### 3.4 Instrumentation and Control

STD DEP T1 3.4-1

Figure 3.4a Safety System Logic and Control (SSLC) Control Interface Diagram

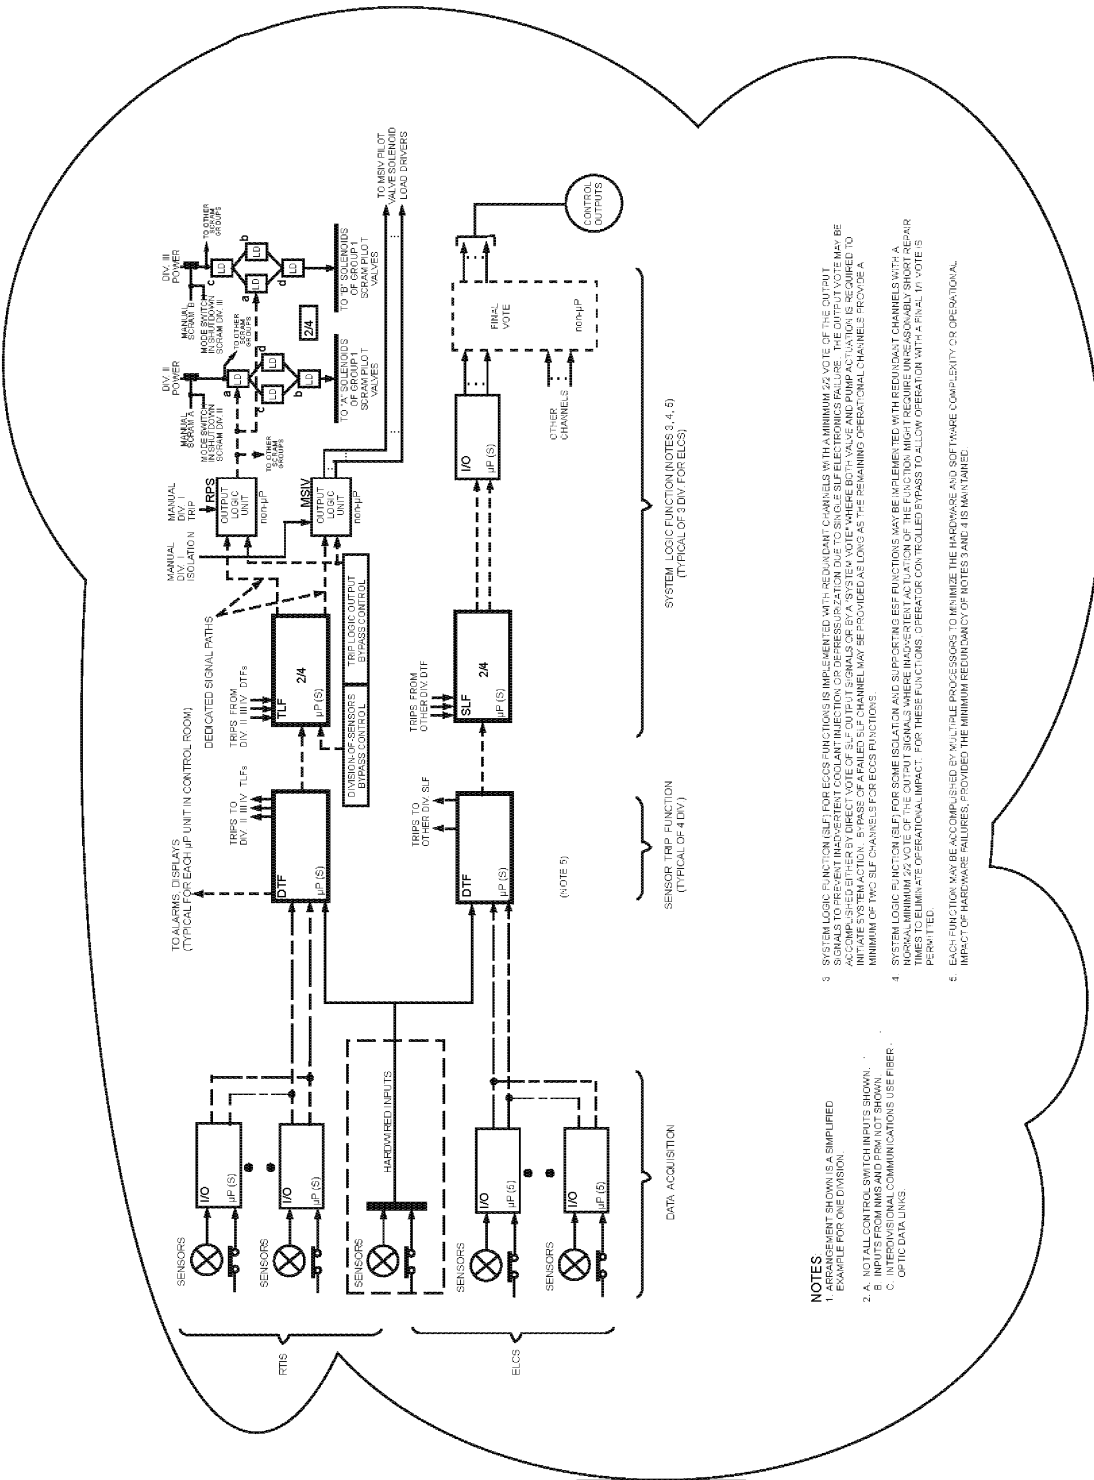
*~~Safety related monitoring and trip logic for the plant protection systems resides in SSLC equipment. SSLC integrates the automatic decision making and trip logic functions and manual operator initiation functions associated with the safety actions of the safety related systems.~~ Safety System Logic and Control (SSLC) is a general term that encompasses the logic and controls associated with safety-related systems. This includes automatic and manual protection and control functions. ~~SSLC generates the protective function signals that activate reactor trip and provide safety related mitigation of reactor accidents.~~ SSLC is primarily implemented through the Reactor Trip and Isolation System (RTIS), which supports the reactor protection and main steam isolation functions, and the ESF Logic and Control System (ELCS), which supports the accident mitigation functions. Also included in SSLC are the Neutron Monitoring System (NMS), the Containment Monitoring System (CMS) and the safety-related portions of the radiation monitoring systems. The relationship between SSLC and systems for plant protection is shown in Figure 3.4a.*

- C. INTERDIVISIONAL COMMUNICATIONS USE FIBER OPTIC CABLES.
3. SYSTEM LOGIC FUNCTION (SIF) FOR ELCS FUNCTIONS IS IMPLEMENTED WITH REDUNDANT CHANNELS WITH A MINIMUM 22 VOTE OF THE OUTPUT OF THE LOGIC FUNCTION. FOR ELCS FUNCTIONS, THE LOGIC FUNCTION MAY BE ACCOMPLISHED EITHER BY DIRECT VOTE OF SIF CHANNELS OR BY A SYSTEM VOTE WHERE BOTH VOTE AND PARALLEL LOGIC IS REQUIRED TO INITIATE SYSTEM ACTION. 5-PASS OF FAILED SIF CHANNEL MAY BE PROVIDED AS LONG AS THE REMAINING OPERATIONAL CHANNELS PROVIDE A MINIMUM OF TWO SIF CHANNELS FOR ELCS FUNCTIONS.

4. SYSTEM LOGIC FUNCTION (SIF) FOR SOME ISOLATION AND SUPPORTING ESF FUNCTIONS MAY BE IMPLEMENTED WITH REDUNDANT CHANNELS WITH A NORMAL MINIMUM 22 VOTE OF THE OUTPUT SIGNALS WHERE INADVERTENT ACTUATION OF THE FUNCTION MIGHT REQUIRE UNREASONABLY SHORT REPAIR TIMES TO ELIMINATE OPERATIONAL IMPACT. FOR THESE FUNCTIONS, OPERATOR CONTROLLED BYPASS TO ALLOW OPERATION WITH A FINAL VOTE IS PERMITTED.

5. EACH FUNCTION MAY BE ACCOMPLISHED BY MULTIPLE PROCESSORS TO MINIMIZE THE HARDWARE AND SOFTWARE COMPLEXITY OR OPERATIONAL IMPACT OF HARDWARE FAILURES, PROVIDED THE MINIMUM REDUNDANCY OF NOTES 3 AND 5 IS MAINTAINED.

Figure 3.4b Safety System Logic & Control Block Diagram

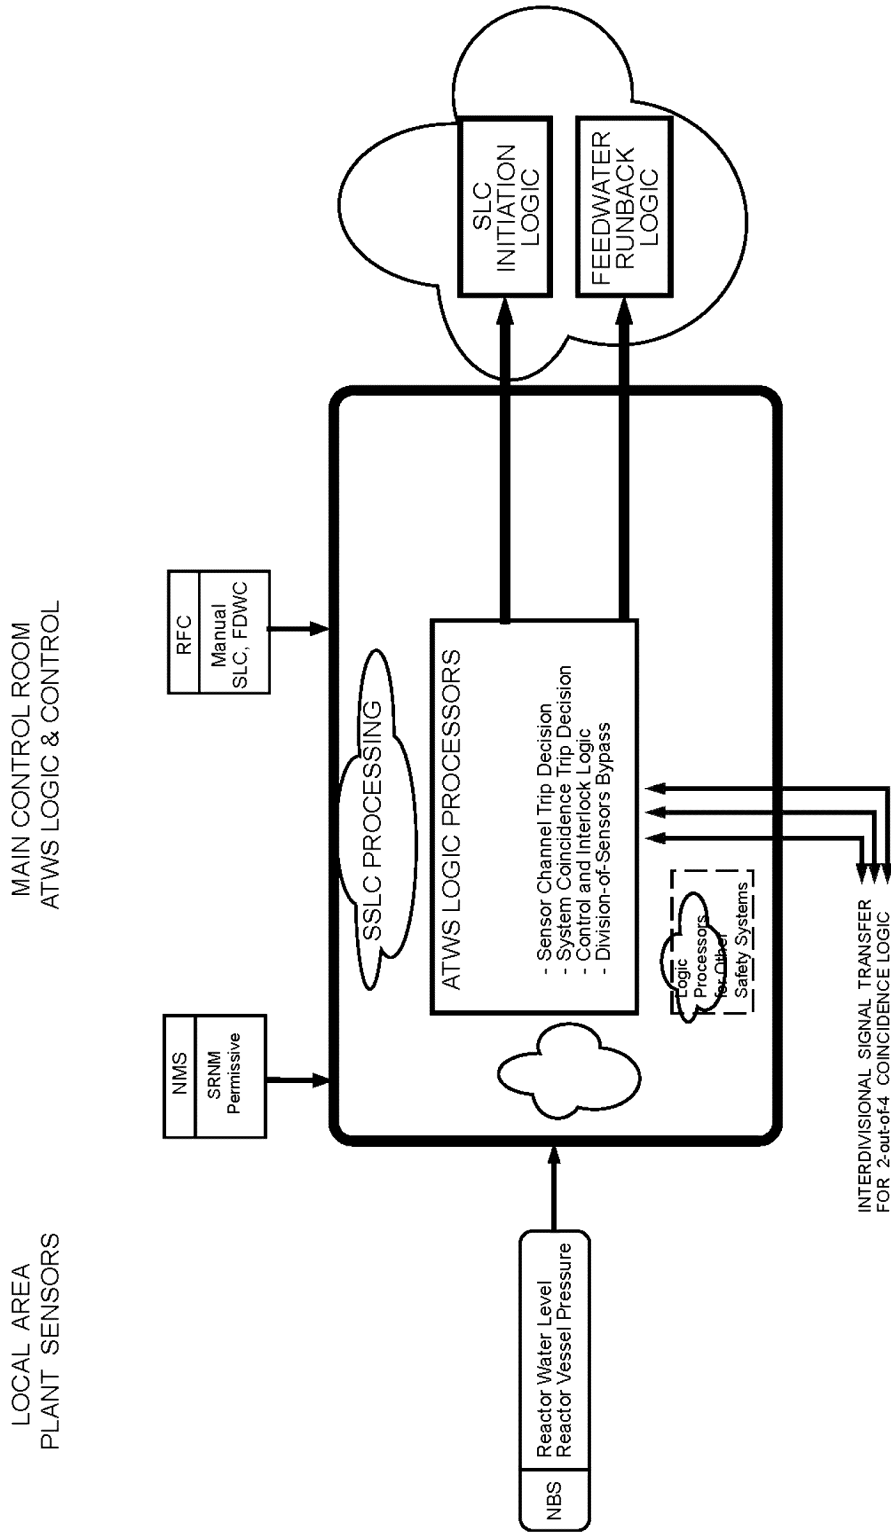
~~The basic hardware functional configuration for one division of SSLC is shown in Figure 3.4b. Each division runs independently (i.e., asynchronously) with respect to the other divisions. The following steps describe the processing sequence and associated function descriptions for incoming sensor signals and outgoing control signals. These steps are performed simultaneously and independently in each of the four divisions:~~

~~As shown in Figure 3.4b, a pair of SLU are located in each of two engineered safety feature (ESF) processing channels, ESF1 and ESF2. ESF1 processes initiation logic for functions which service the reactor vessel at low pressure (e.g. RHR), while ESF2 provides the same support for the~~
